ROCKY FLATS SITE REGULATORY CONTACT RECORD

Purpose: Exploratory excavations to greater than 3 feet below grade generally between the former Interceptor Trench Pump House and Solar Ponds Plume Treatment System

RFLMA Contact Record 2008-03

Figure 1. Approximate Location of TMST Transfer Line

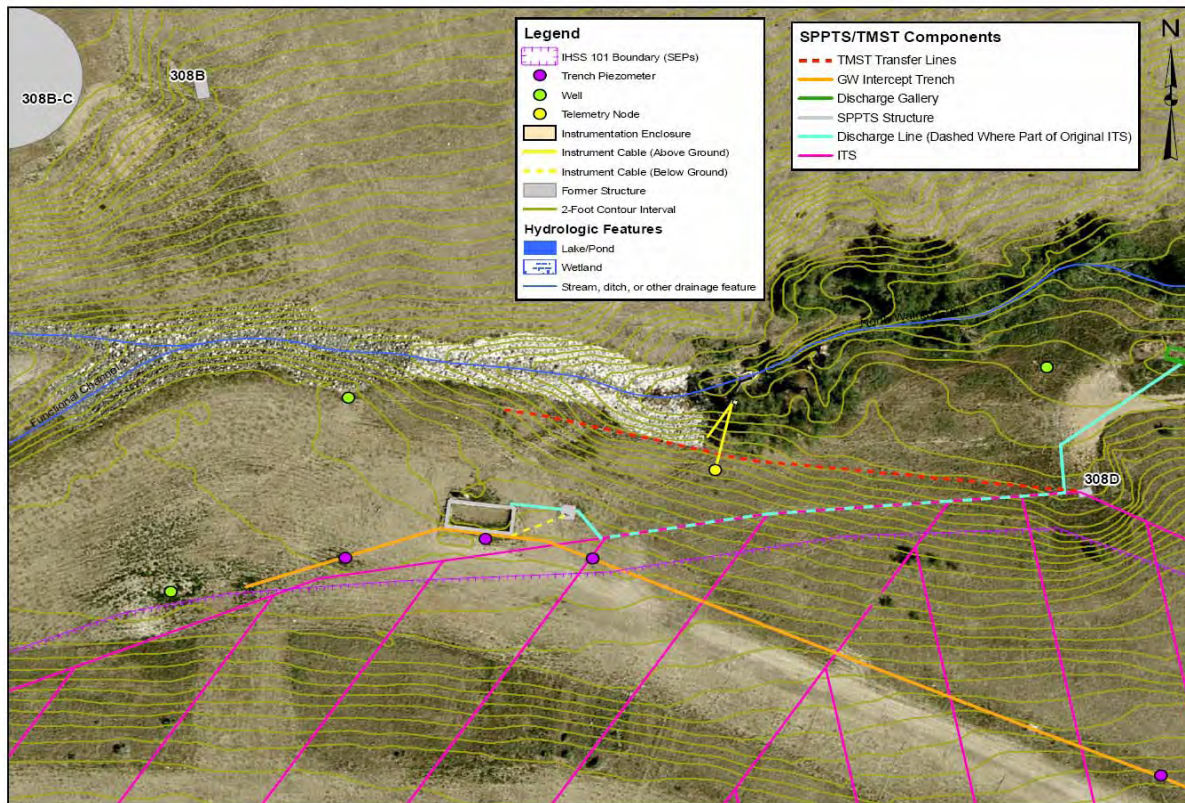
CDPHE has requested that the following information be included in contact records for soil excavation:

1 - Provide information about any remaining subsurface structures in the vicinity so that the minimum cover assumption won't be violated (or state that there are none if that is the case)-

2 - Provide information about any former IHSSs/PACs or other known soil or groundwater contamination in the vicinity (or state that there is no known contamination)-

3 - Resurvey any new surface established in subsurface soil, unless sufficient existing data is available to characterize the surface (or state that the excavated soil will be replaced and the original contours restored)

The exploratory excavation is in the vicinity of the former ITPH, known as building 308D. The building was removed as documented in the *Type 1 Facility Closeout Report for Buildings 308B and 308D* (September 22, 2003). The closeout report indicates that utilities were disconnected and capped three feet below grade.

The closeout report indicates that there is no contamination present in the remaining soils and that this area was not an IHSS. The *RI/FS Nature and Extent of Soil Contamination* figures do not indicate soil contamination in this area. Groundwater in the vicinity is impacted by the Solar Ponds Plume. Any groundwater that is encountered will be collected from the excavation, if necessary, to conduct the investigative work. The groundwater will be pumped from the excavation to the surface generally south of the excavation area to allow this water to seep back into the ground.

All excavated soils will be returned to the excavation, and original contours will be restored.

Resolution: Carl Spreng, CDPHE, approved the potholing work as described in this contact record.
